As We Heard It Report #2

North River Road Traffic Calming Study

Based on the traffic data and the results from the initial online survey, a recommended traffic calming plan was developed. In the summer of 2024, a second online survey was conducted to gather feedback on the recommended traffic calming plan. This AWHI report includes the results from the second online survey.

Recommended Traffic Calming Plan

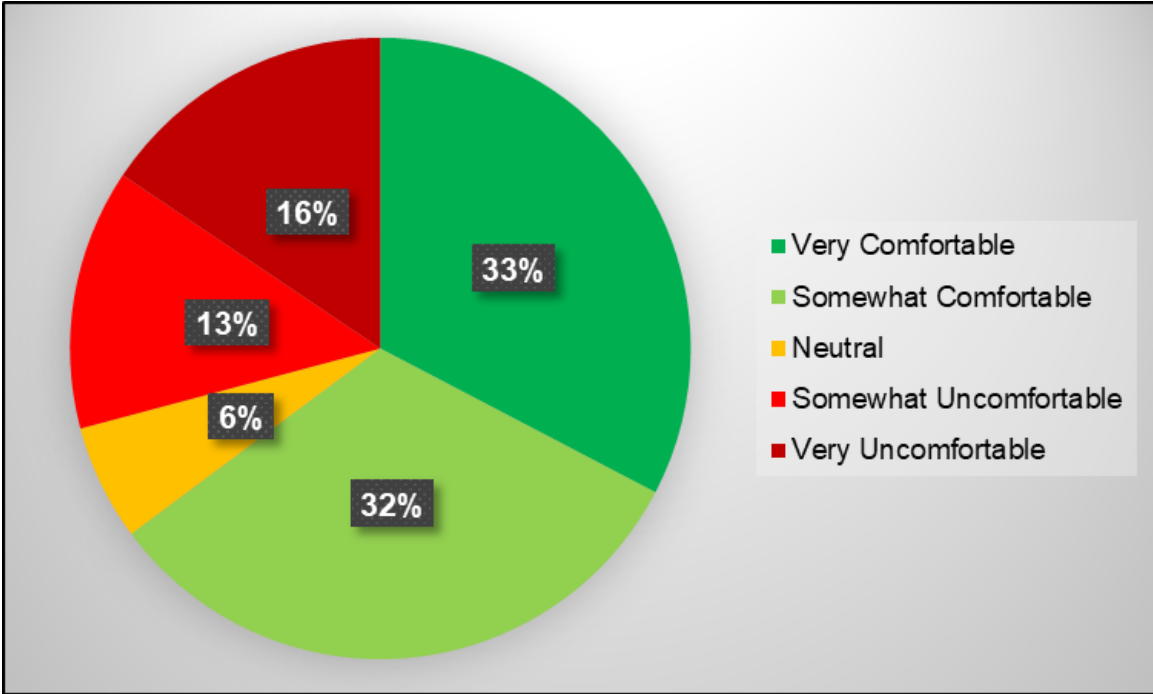
Speeding
Speeding is a concern along North River.
There is speeding along North River especially on Sundays when people attend church.
More traffic calming measures are needed because of speeding.
Have not seen significant problems with speeding along this section of North River.
Drag racing / drivers testing maximum speed limits along North River.
Reduce the speed limit to 30km/h.
Speeding on North River south of Queen Mary.
Drivers speed around corners and on streets to avoid the Vanier Parkway.
Add more obvious speed signs.
Lower speed limit to help deter drivers from using North River as a shortcut.
Have not observed speeding along North River.
It's not the drivers parking on North River that are speeding. It's the drivers trying to bypass the Vanier Parkway.
Noisy.
Drivers do not obey posted speed limits.
Traffic calming plan does not address speeding on Sundays between Queen Mary and the church.
Do more to get drivers to stop speeding.

Narrow the road to reduce speeding. North River is too wide and drivers feel comfortable speeding.
Permanent Traffic Calming Measures
Proposed traffic calming measures will not help with enforcing stop control compliance.
Proposed traffic calming measures are welcome and will improve things.
Implement green infrastructure at the proposed raised intersection at North River and Donald. More creative water management solutions are needed that introduce biodiversity.
Proposed raised intersection at North River and Donald will be great as ponding is a major issue for pedestrians.
Traffic calming should only be implemented in dangerous situations.
Proposed traffic calming measures appear to be sensible and will help lower speeds, increase stop control compliance, and increase pedestrian / cycling safety.
No need for another speed hump near the church.
Vertical traffic calming measures will slow buses and emergency vehicles.

Traffic calming measures should not distract drivers from watching out for other road users.
Proposed raised crosswalk / intersection will not help speeding.
Existing speed humps on North River work great.

Proposed traffic calming measures do not harmonize well with the proposed measures north of Donald. Cyclists are particularly at risk.
Proposed traffic calming measures are excessive for such a small segment of the street. The existing speed humps work.
No additional traffic calming measures are needed.
Traffic calming measures are not the answer. They are only a temporary fix.
Proposed traffic calming measures are not enough to keep people safe.
Does not support the narrowing of traffic lanes.
Does not support bulb-outs.
Does not support the raised crosswalk on Queen Mary due to potential flooding.
Proposed raised crosswalk on Queen Mary will create issues with snow removal.
Implement a pedestrian crossover instead of the raised crosswalk on Queen Mary.
Any modifications must be made accessible for people with mobility aids and wheelchairs. Many seniors in the area.
Implement speed humps at regular intervals from Donald to Queen Mary.

Make curbs level with the street to enable stroller and wheelchair access.
Proposed plan is a good start.
Existing traffic calming measures (permanent and temporary) are sufficient.
Implement more than one speed hump on North River south of Queen Mary.
Supports proposed raised crossings but would prefer a protected intersection.
Use temporary planters to create bulb-outs at intersections.
Proposed measures are not significantly different from what currently exists.
Implementing proposed traffic calming measures will help reduce speeds and cut-through traffic.
Proposed raised intersections will reduce speed but not traffic volume.
Implement more speed humps.
Implement the traffic calming measures.
Supports the traffic calming measures especially the raised intersection.
Two to three speed humps would suffice.
Reduce curb radii at North River and Donald to slow right turning vehicles.
Narrow Donald where it meets North River to limit speeds of vehicles turning left from North River. Consider adding an island in the middle near the intersection.

Traffic calming is needed along the southern section of North River. Speeding and lots of traffic during church events. It is also a place where people hang out.
Do not implement additional speed humps.
Currently too many traffic calming measures that distract drivers.
Do not implement the raised crosswalk at Queen Mary. There are no issues with crossing at this intersection.
Proposed traffic calming measures would make the neighbourhood an unpleasant commuting experience.
Proposed traffic calming measures are not enough. Somebody (person or pet) is going to get killed.
Already too many traffic calming measures along North River.
